SIB 65 25 19

2021-06-07

RECALL 19V-853: DRIVER'S FRONT AIR BAG (NADI) INFLATOR

This Service Information Bulletin (Revision 13) replaces SI B65 25 19 **dated April 2021**.

Basic Driver's air bag, showing the location of the parts label.

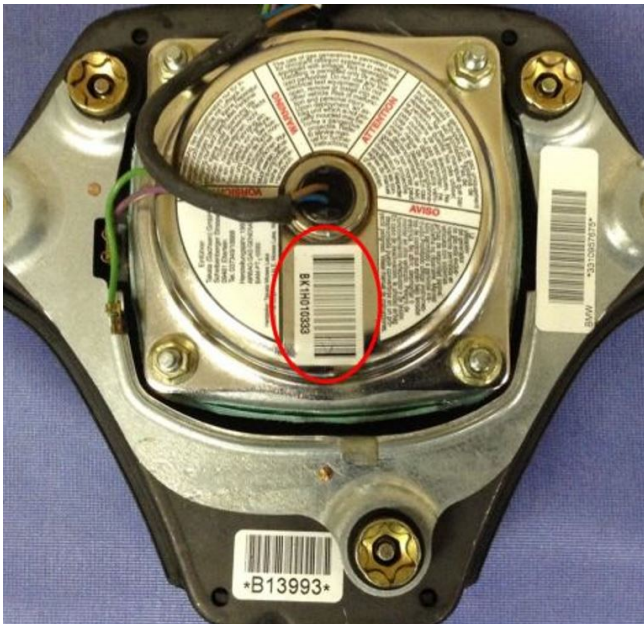
Once the air bag is removed and the wiring is disconnected, turn air bag over to read the parts label(s) on the gas generator on the back.

Gas generator serial number decoding:

- Digits 1-2 = Type of gas generator
- Digit 3 = Production Line
- Digit 4 = Production year
- Digit 5-11* = Serial #

***NOTE: The serial number can have 10 or 11 characters. Only the first 10 characters counted from the left are relevant for the check. The 11th digit can be disregarded for the repair covered by this SIB**

All original Gas generator serial numbers which begin with BK should be replaced.
